7009 GREENWOOD AVE N

Design Review Recommendation Meeting
May 1, 2017
SDCI Project # 3023260

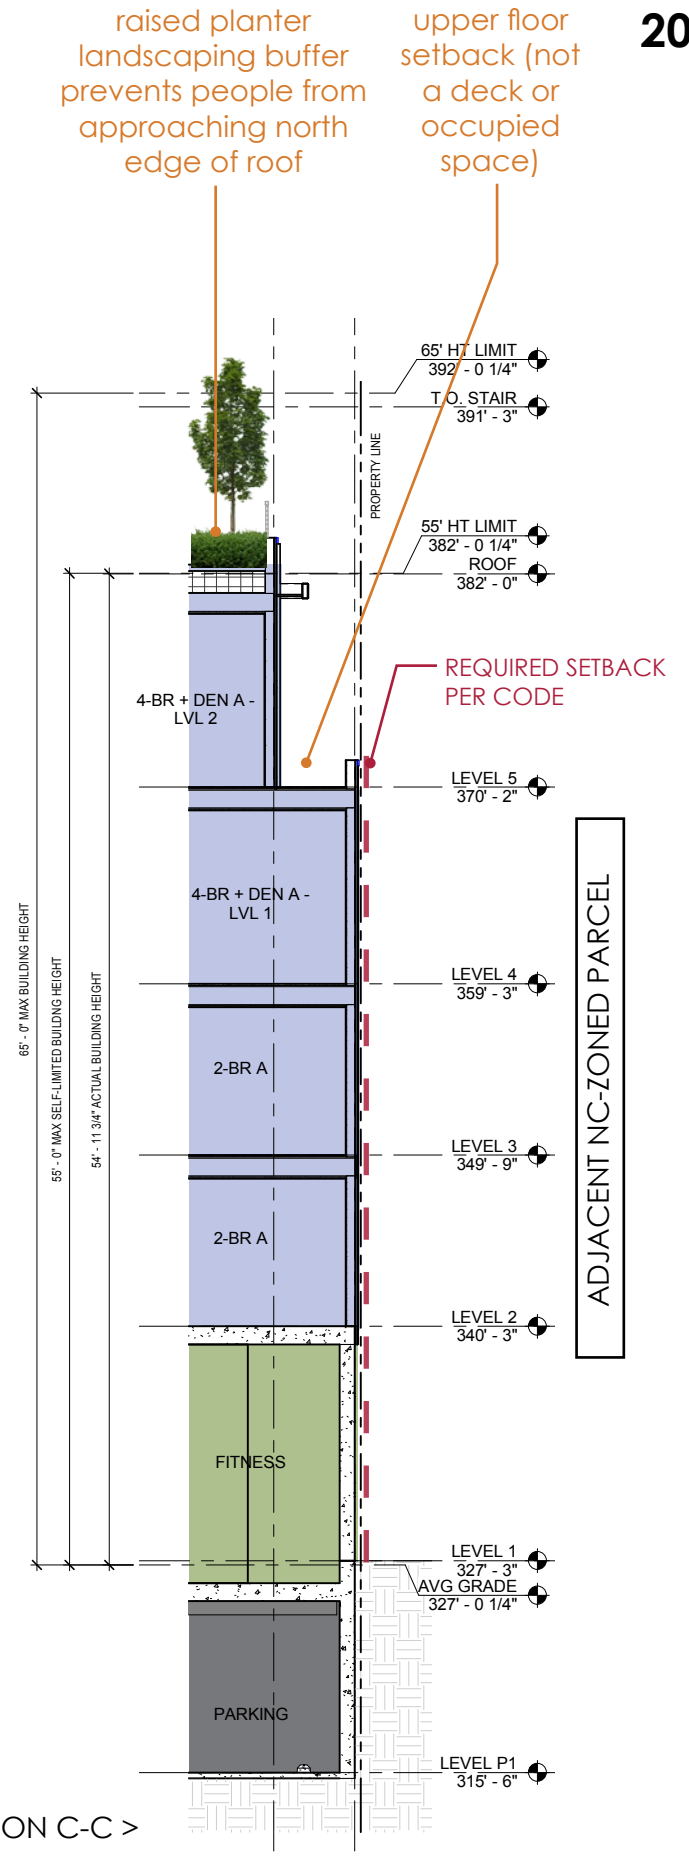
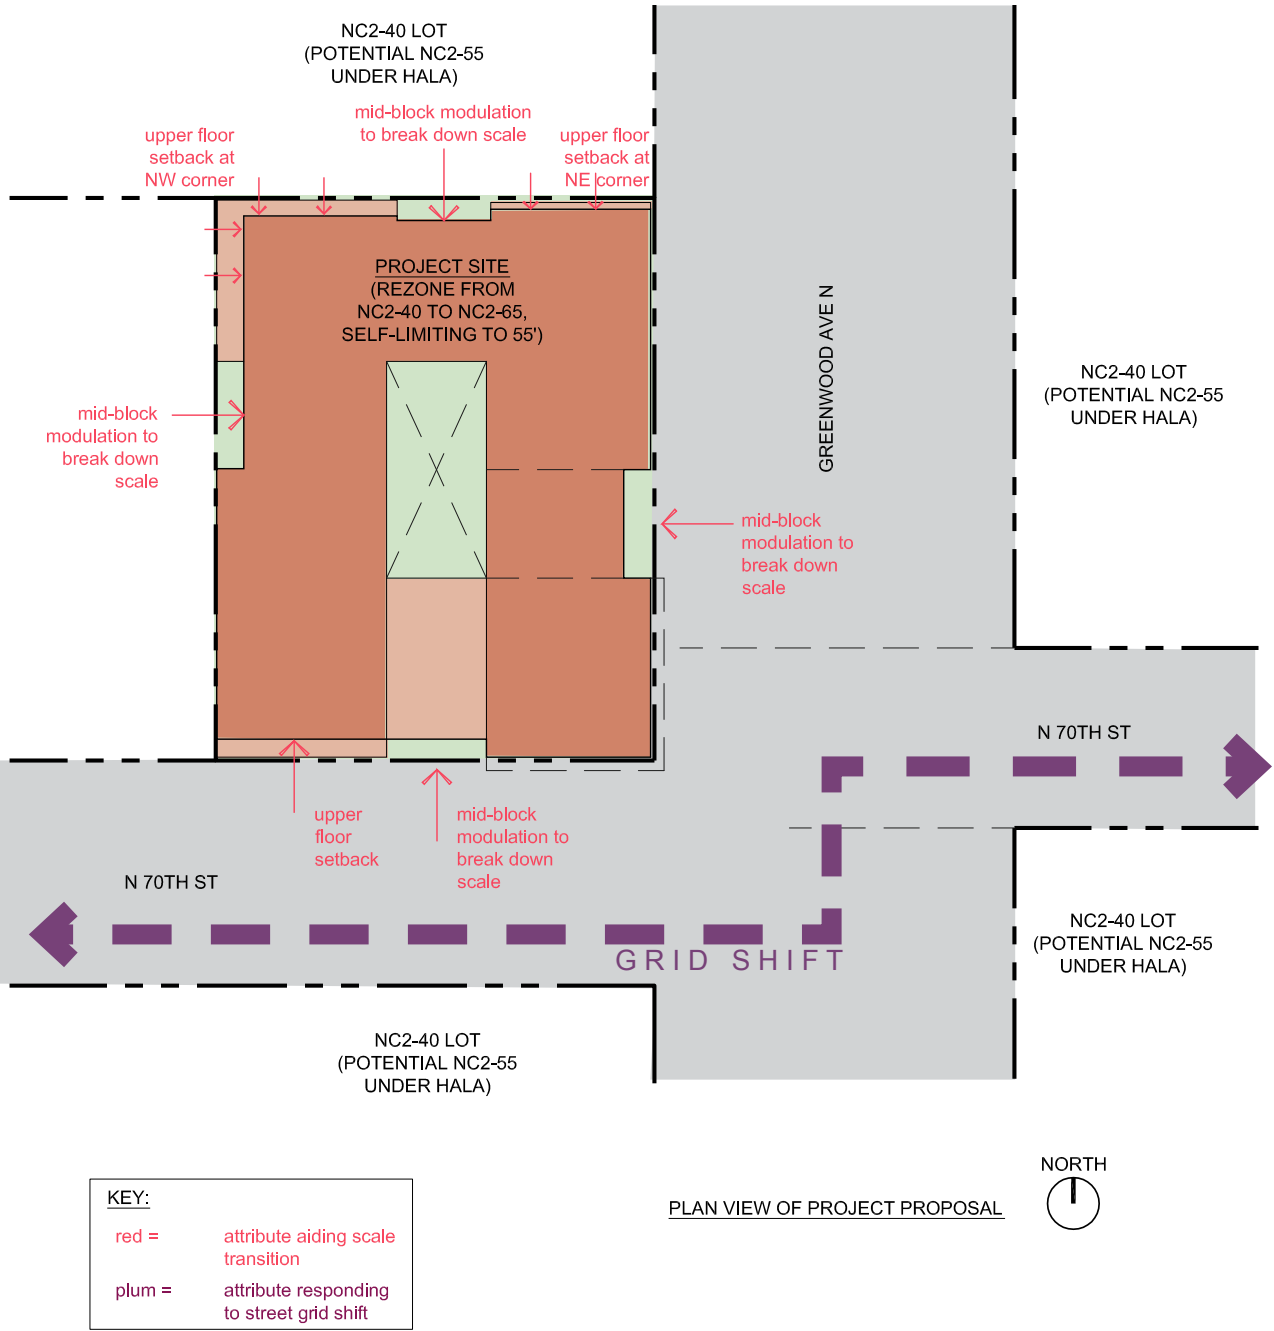
direction: the Board expressed concern regarding “building mass and shadow impacts of the increased height in relationship to the adjacent single family” uses. At the Recommendation Meeting, the Board requested a “thoughtful transition,” including privacy studies to reduce line of sight concerns.

response: to address privacy concerns towards the property to the north, fenestration has been limited facing north and at the roof deck strategically-placed unoccupied green roof bands reduce line of sight concerns of building residents looking down to adjacent properties to the north. Toward the west, the two adjacent parcels are now under common ownership and provide a minimum 55’ wide buffer to adjacent single-family uses not under common ownership.

- upper floor setback
- mid-block modulation to break down scale
- outline of proposed building
- location of windows in proposed building does not overlap neighboring buildings' windows
- no fenestration and a recess in building opposite neighbor's windows

CURRENT NC2-40 ZONING SHADOW STUDIES
(showing 44' allowable height)

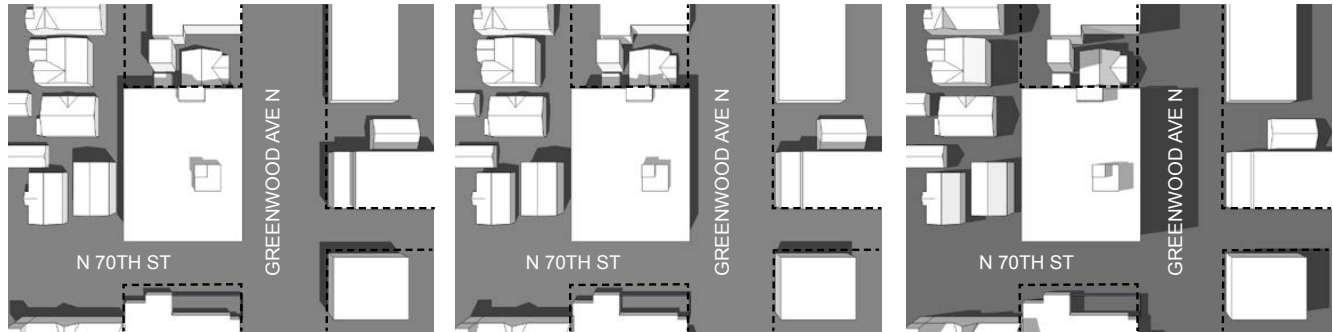
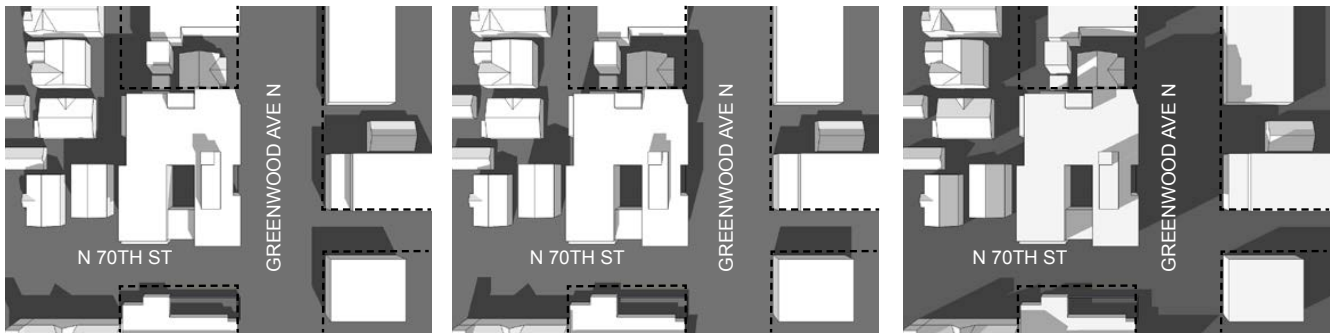
direction: “At the Recommendation Meeting, the Board requested additional shadow studies”
showing impact to the single family structures to the north and west

response: a shadow study of impacts to adjacent north and west properties is provided at right. Primary properties impacted are the neighbor to the north (zoned neighborhood commercial and likely to be upzoned to HC2-55 under HALA in the near future) and to the northwest, a single-family lot. At the NW corner, upper floor setbacks are proposed to partially mitigate shadowing to the northwest. The two lots bordering to the site to the west are under common ownership.

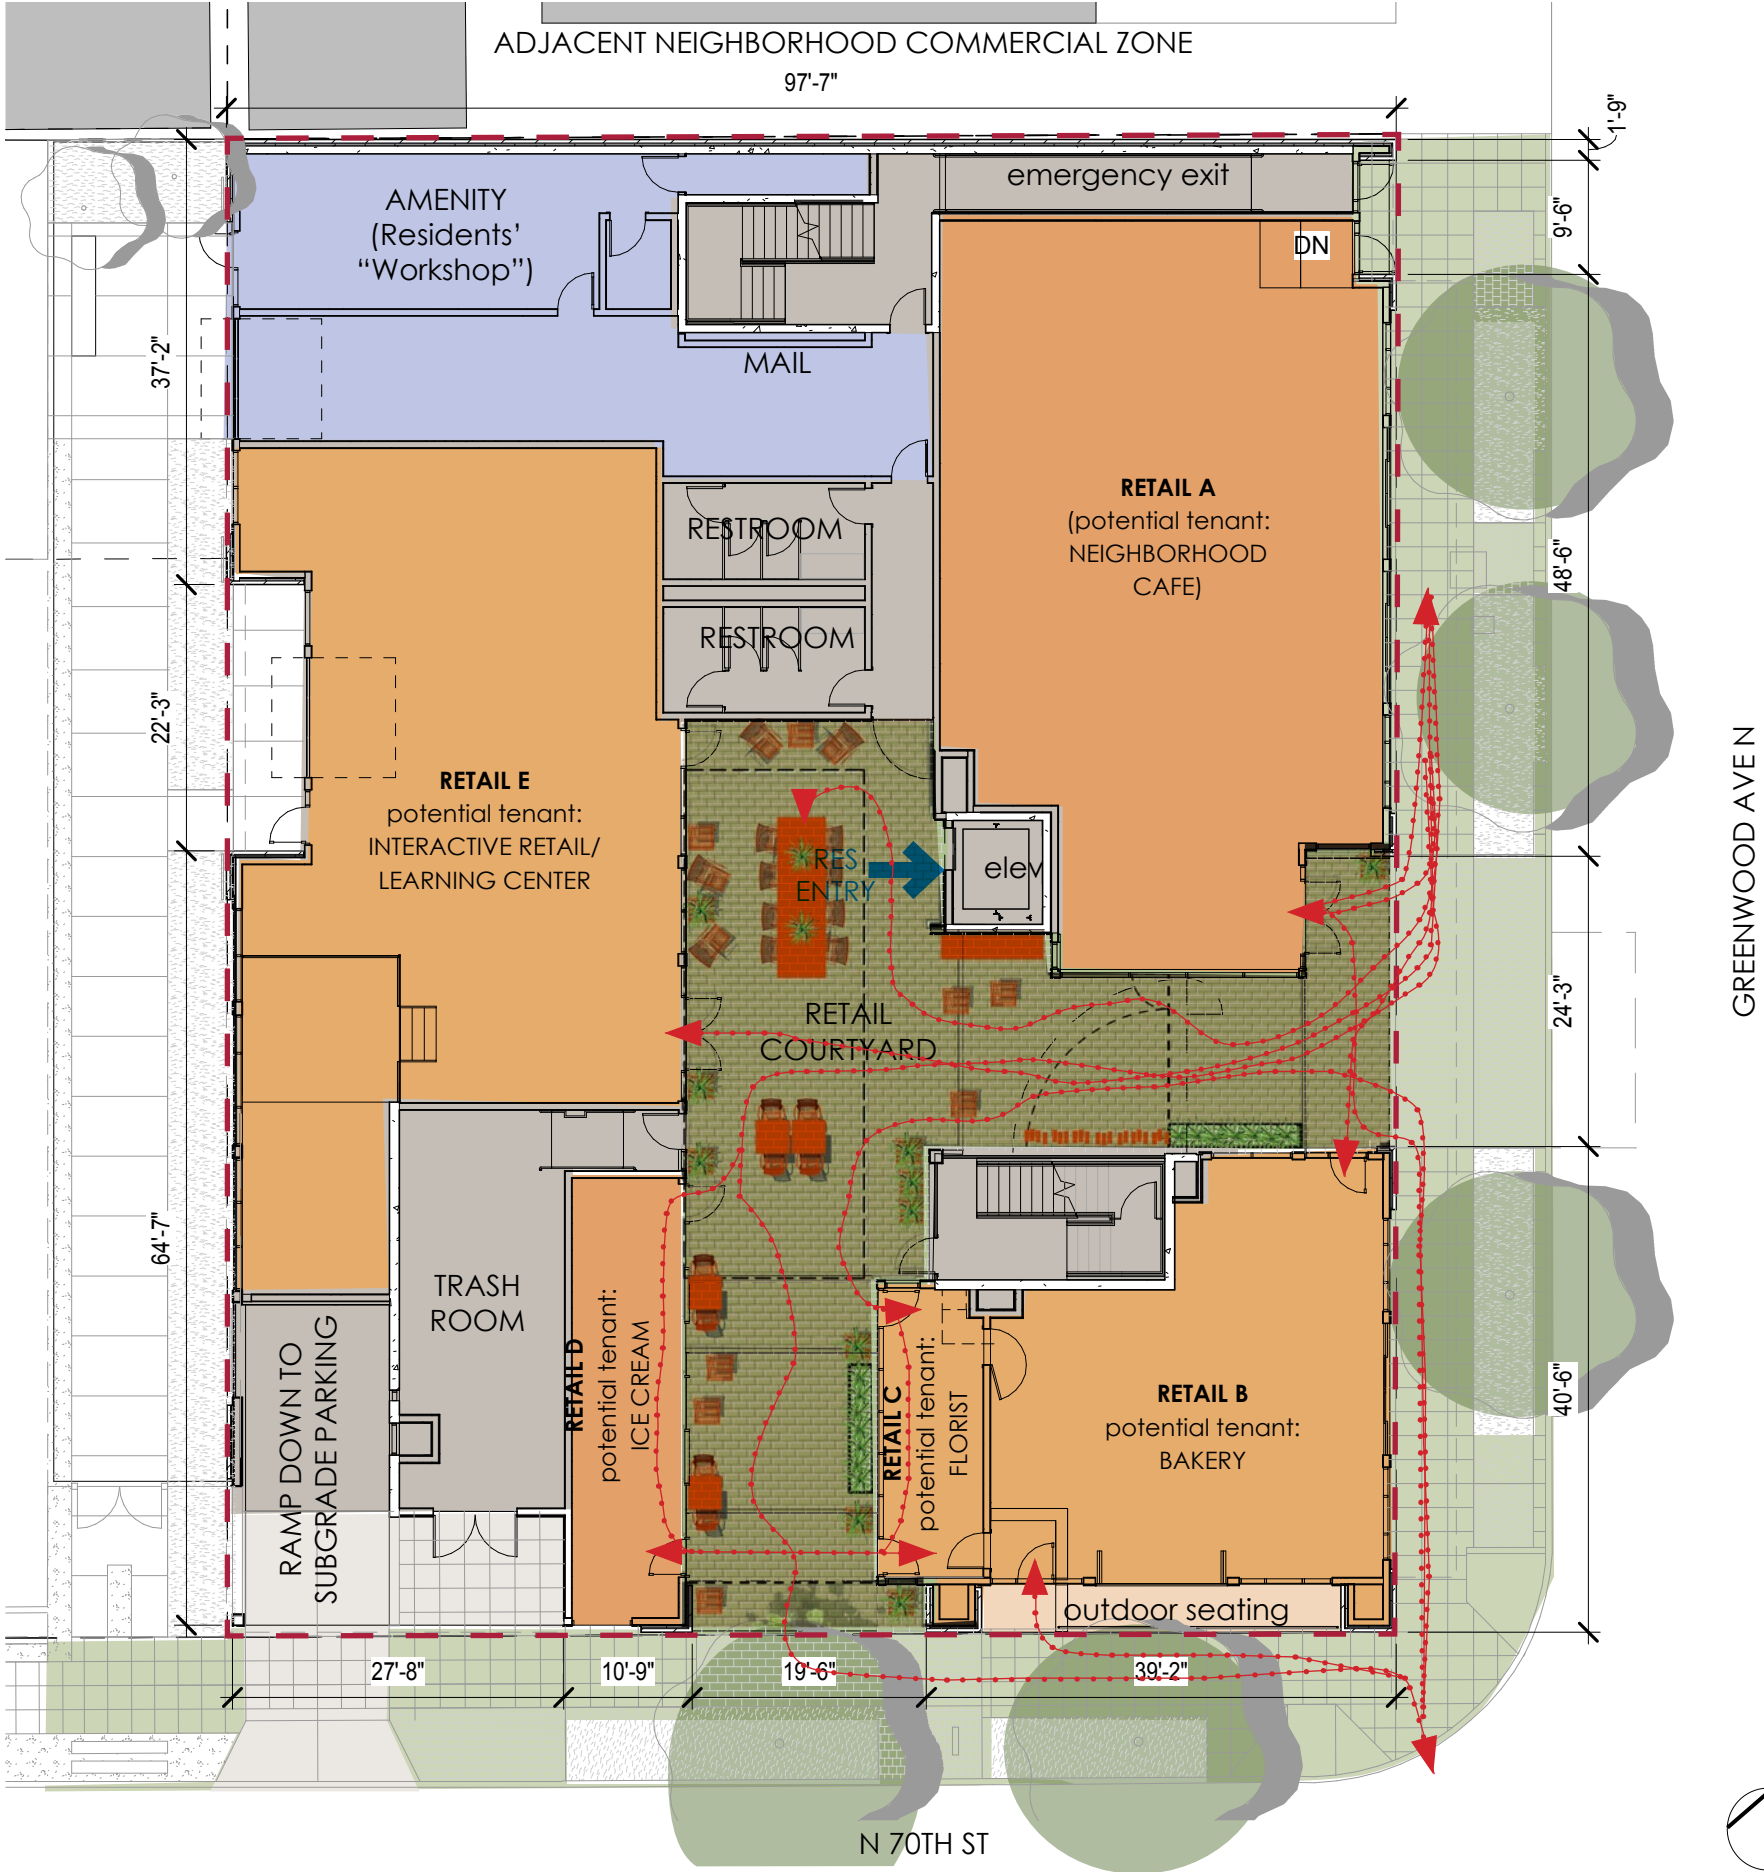
direction: "The Board noted that the open retail courtyard was integral to the success of the architectural concept." At the Recommendation Meeting, the Board requested more information about programming and the legibility of the space to residential, retail, and public users

response: The open retail courtyard has been retained from EDG and connects Greenwood and 70th to the site interior. The previous courtyard connection to the single-family parcel at the west has been eliminated to maximize privacy to the west and better provide a use intensity transition. The internal courtyard is activated at ground level by flanking retail spaces at a variety of scales. Small "micro retail" is also included to maximize varied uses fronting the space.

ground floor storefront elevation along Greenwood Ave N ^

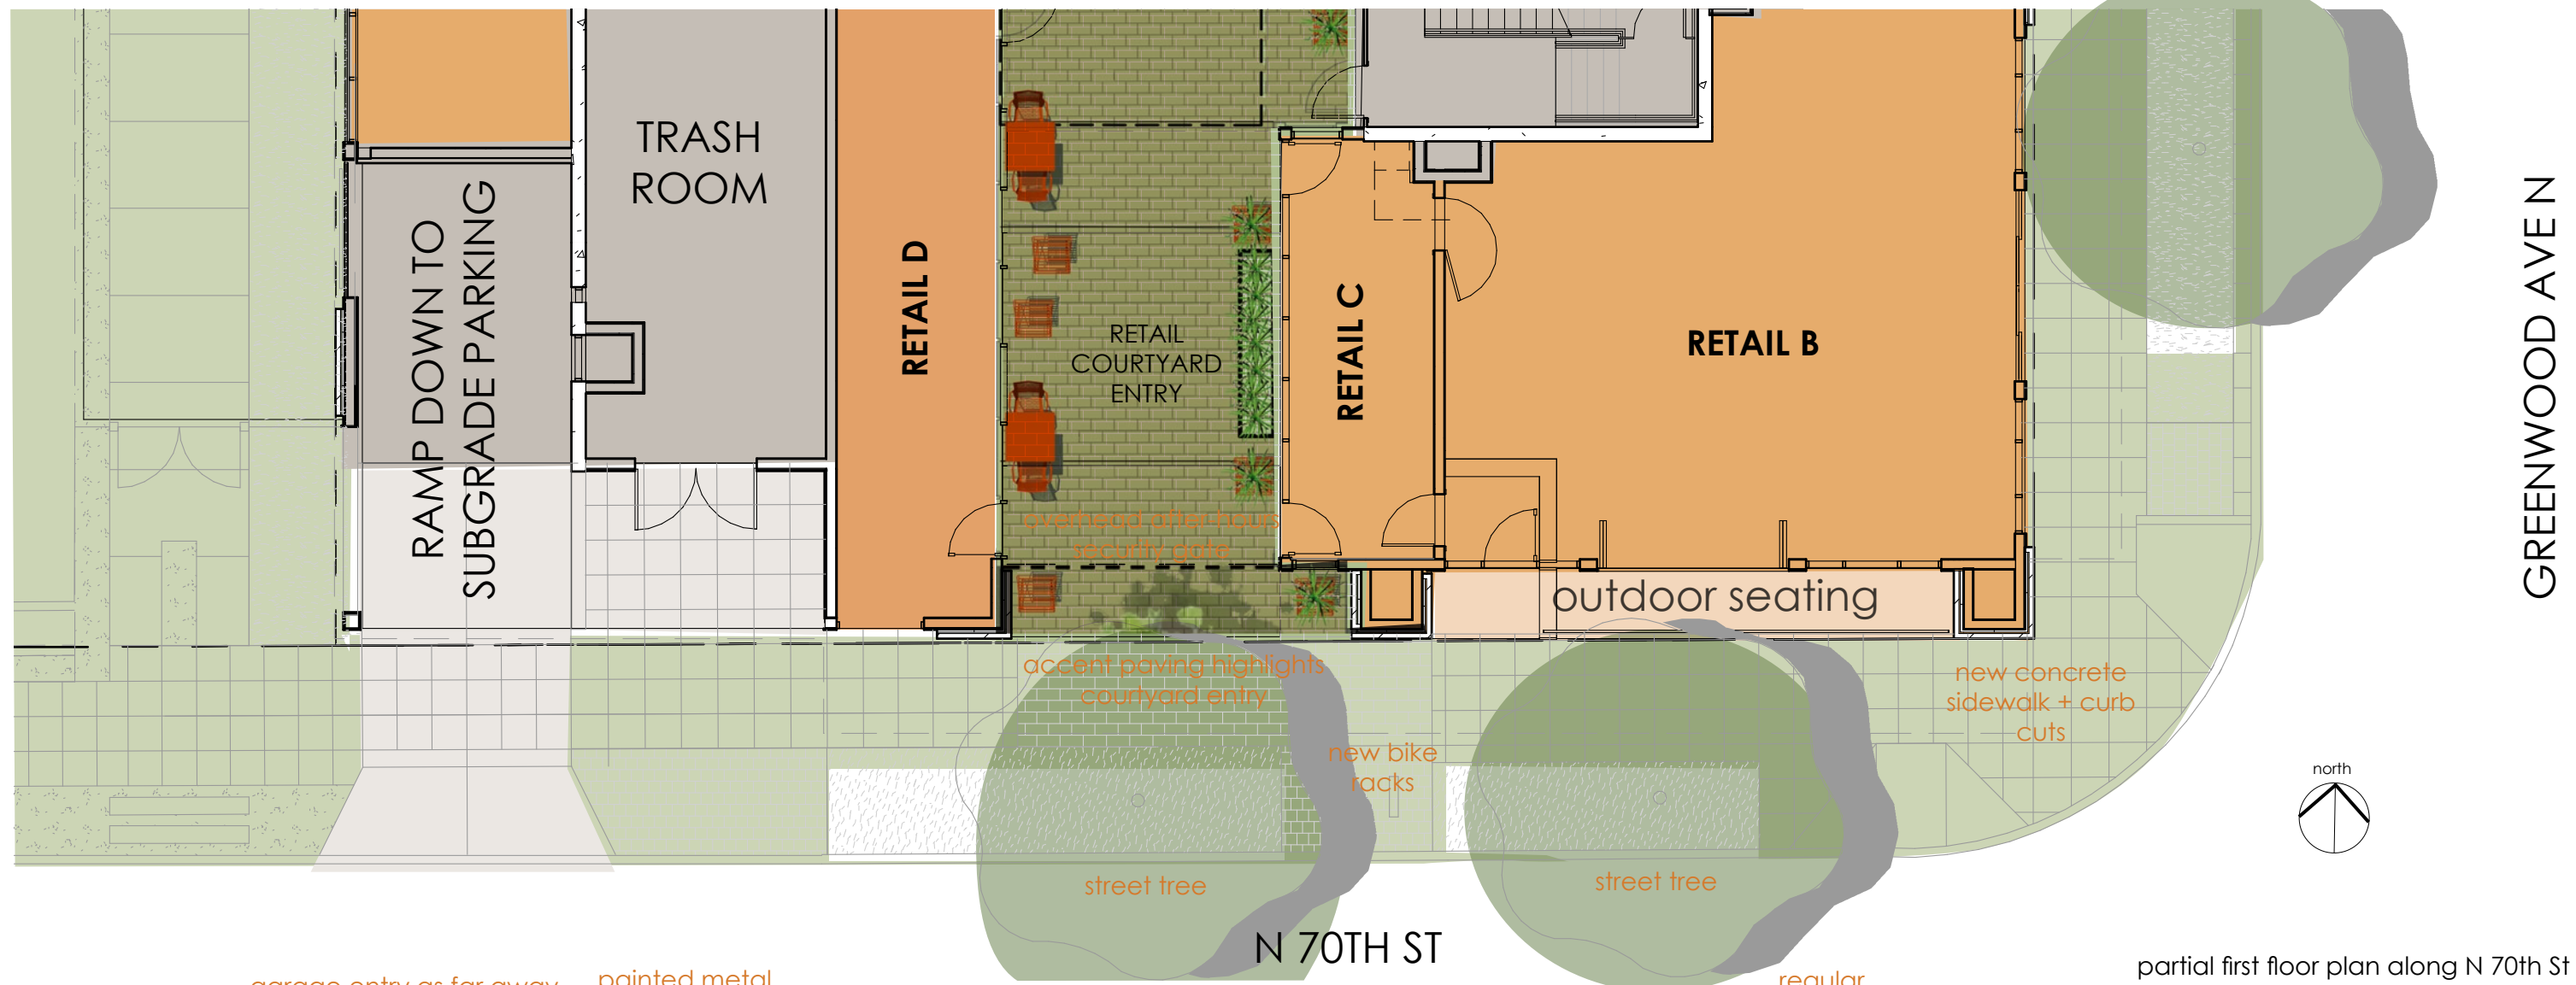
direction: "The Board agreed that the commercial storefronts along Greenwood Ave N required the same level of design detail as the interior courtyard spaces" and should be developed consistent with the neighborhood-specific guidelines for commercial corridors and storefront design. The Board additionally requested more information on proposed right-of-way improvements and how the design "contributes to and enhances the existing neighborhood character."

response: The ground-level, street-facing facade fronting Greenwood Ave N has been further developed to include ample transparency and a regular human-scale fenestration rhythm reflective of the facade above. The design follows the Greenwood/Phinney Design Guidelines as it is built up to the sidewalk [CS2.I.i.] with a "utilitarian, non-flamboyant, traditional architectural style" consistent with existing character along the Greenwood corridor [CS3.I and CS3.II]. Brick is brought down to the building base and lends texture, durability, historic character, and human scale. Continuous overhead weather protection is provided [PL2.I.i.c], which coupled with the transparency of the ground-floor facade encourages pedestrian activity along the sidewalk. Right of way improvements include new street trees and sidewalk paving, with accent paving highlighting the mid-block courtyard entry. The design guidelines encourage mid-block connections, so the mid-block retail courtyard entry is highlighted in both the building facade design, sidewalk accent paving, and associated gap in street tree grid. Lastly, all vehicle and "back-of-house" spaces are provided away from the Greenwood Ave pedestrian experience.

- brick brought down to building base
- regular rhythm of human-scale storefront windows
- board-formed concrete base
- recessed entrances
- under-canopy signage
- continuous painted steel w/ light stained wood soffit canopy
- pedestrian-scaled lighting
